Doc.-No.:AE-TD-01 Date: 20.02.2007 Revision: Rev. date:	Changes	
Page: 1

Minor changes according EBH class 1. and 2.
 of TD 400 (Omega Tandem with Quick 400)

TD 400 (Omega Tandem with Quick 400)

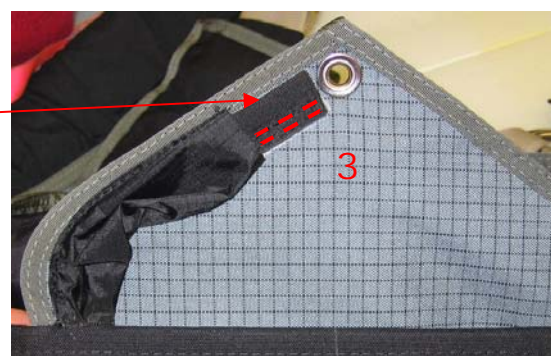
The modification is similar to the modification of the V1R1 (Omega with Quick / Rush).

The already existing housing and cutter mount must be removed from flap no. 1.

There must be cutted a small hole circa 15 mm in flap no.1 above the **attachement and bartec** of flap no. 3 (middel flap) and the edges of the hole must be melted with a lighter.

The elastic cutter mount must be sewn close to the grommet-like shown in the figure below.

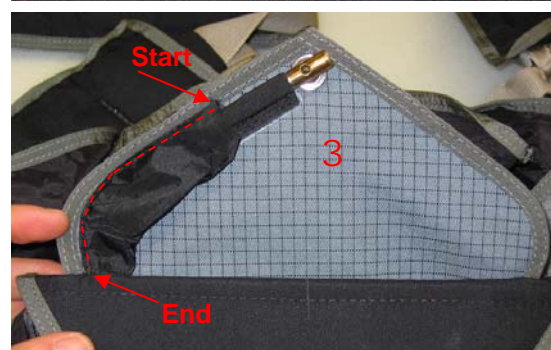
The sticky fabric housing must be fixed next to the binding tape of flap no. 3, thru the hole in flap no. 1 and ends in the wire pocket of the AAD setup.

The left side of the housing must be sewn to flap no. 3. The start and end of the sewing must be tacked.

The end of the sewing should be as tight as possible to flap no. 1.
